# URBAN DESIGN COMMITTEE

2. [25<sup>th</sup> & Vine Redevelopment](#)  
– [UDR21024](#)

TO: **Urban Design Committee**  
FROM: Stacey Hageman  
RE: Meeting of April 6, 2021  
DATE: March 31, 2021

**ITEM 2: 25<sup>th</sup> & Vine Redevelopment**

**1 Building B South Elevation**  
 SCALE: 1/8" = 1'-0"

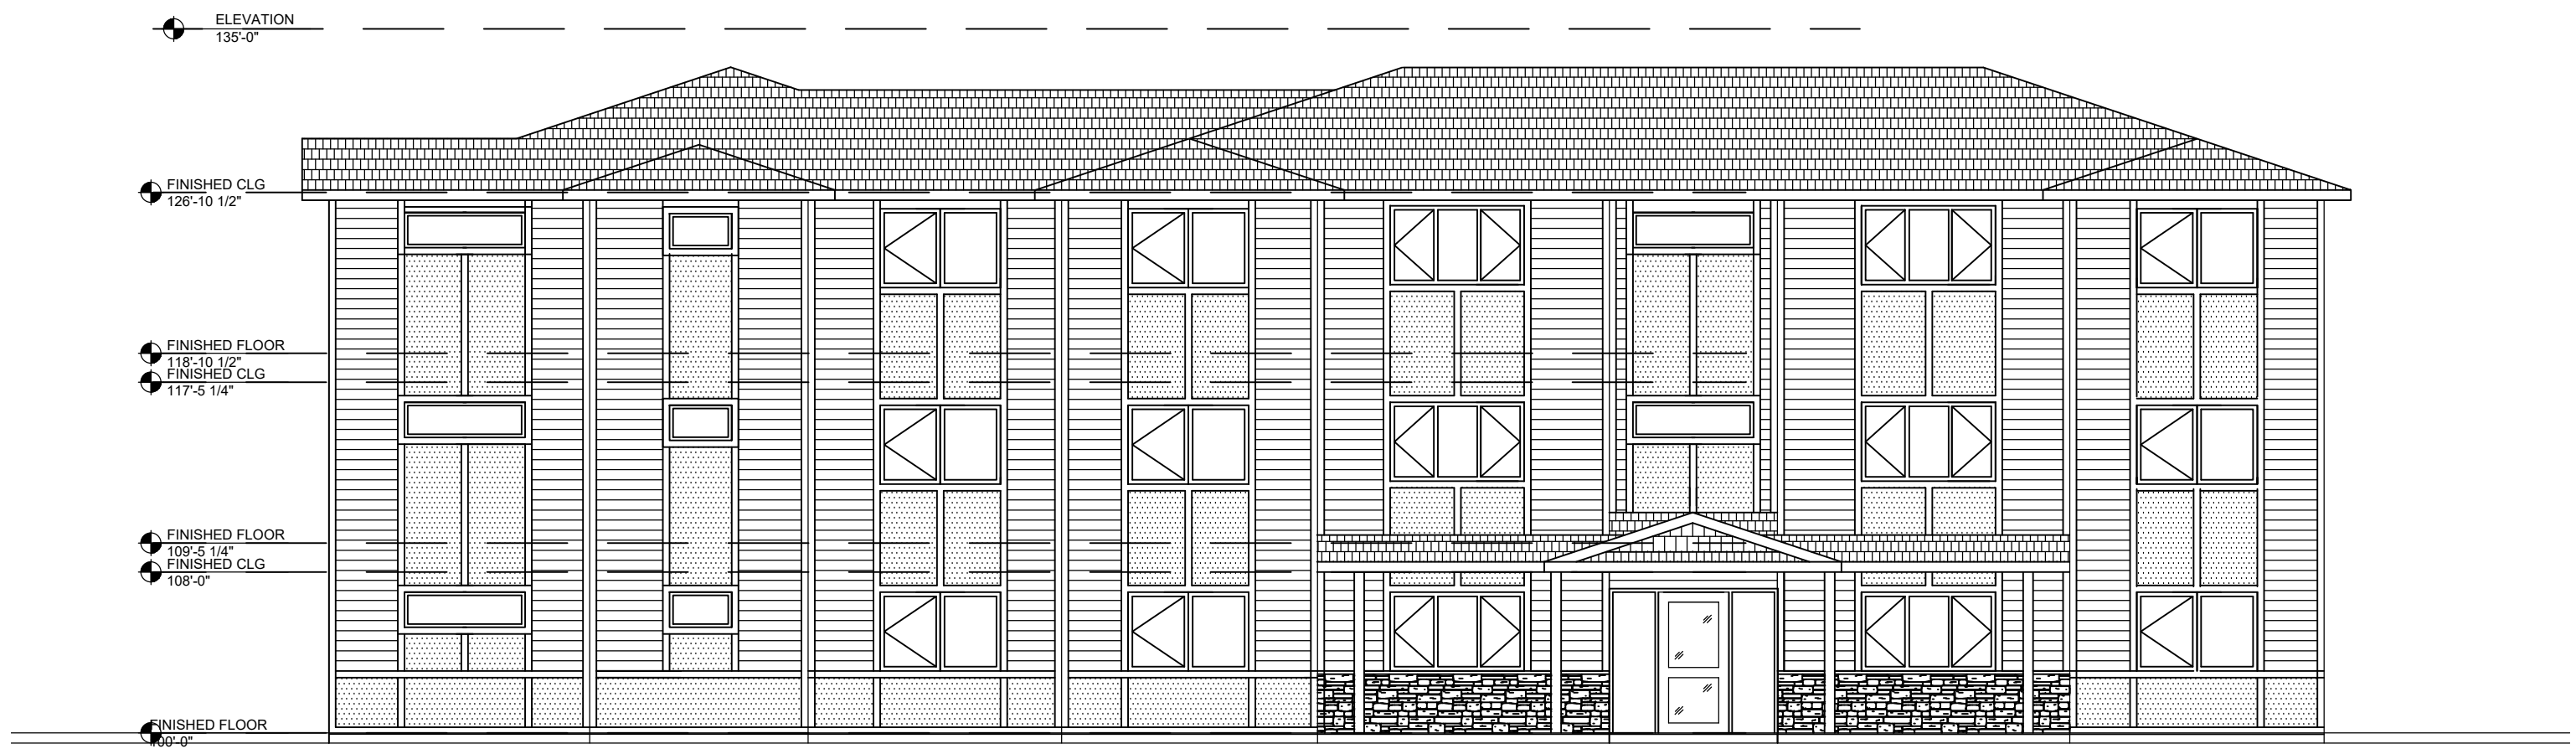
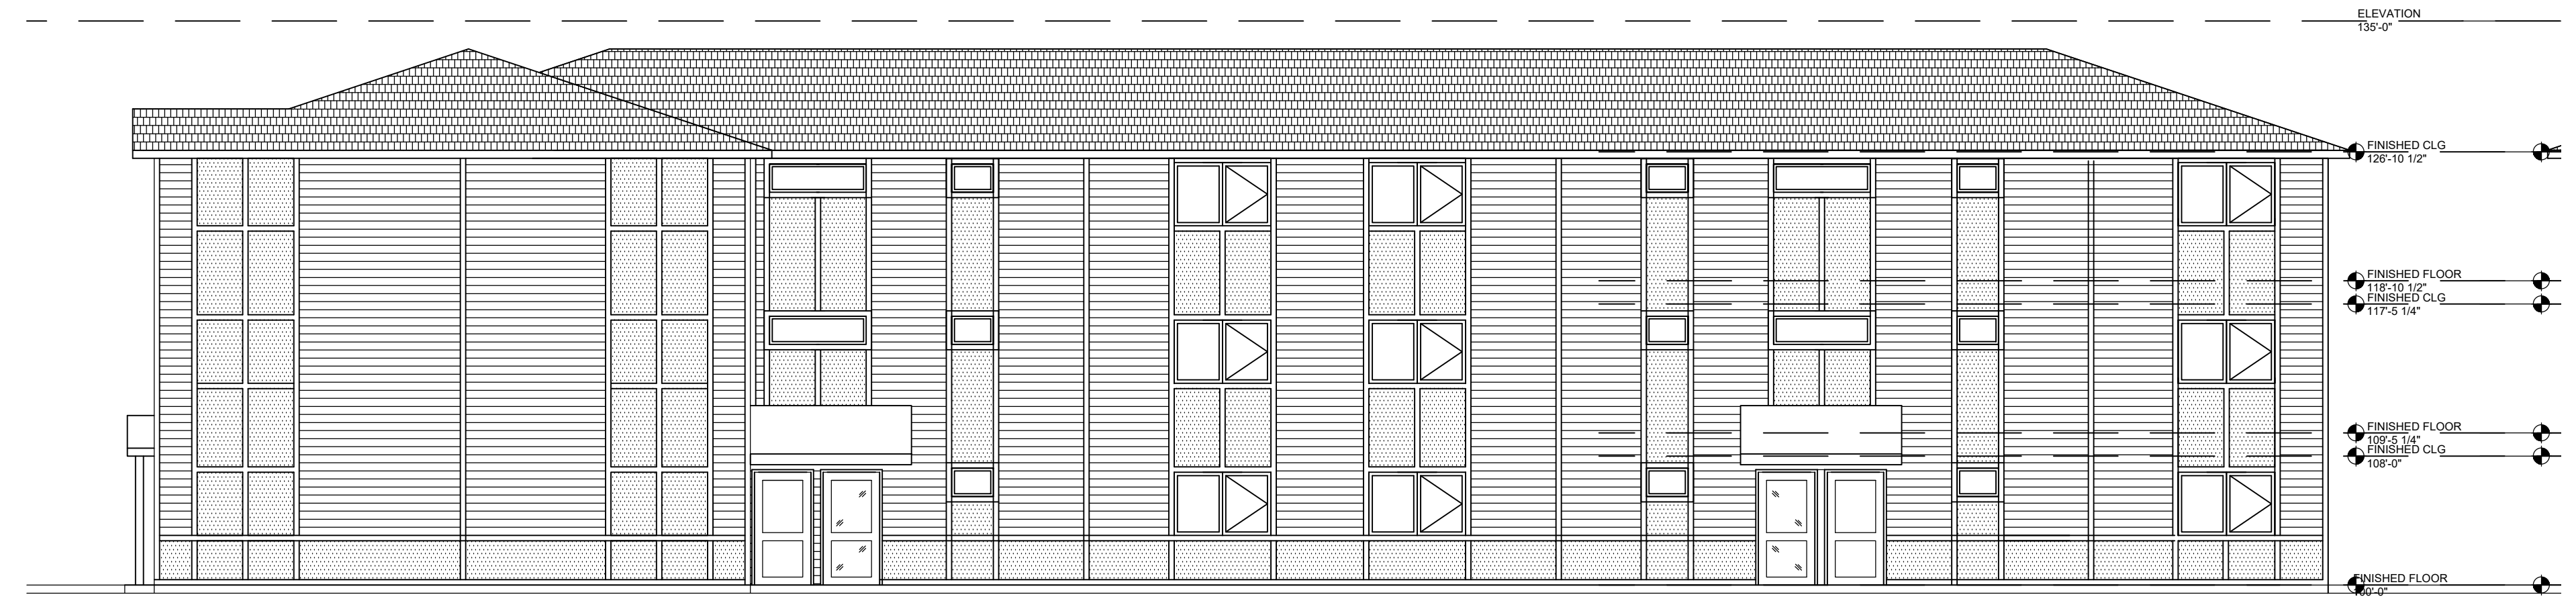
The façade is articulated with roof features and offsets in the façade. Methods to further articulate the Vine Street façade should be considered. For example, color could be used to provide variation.
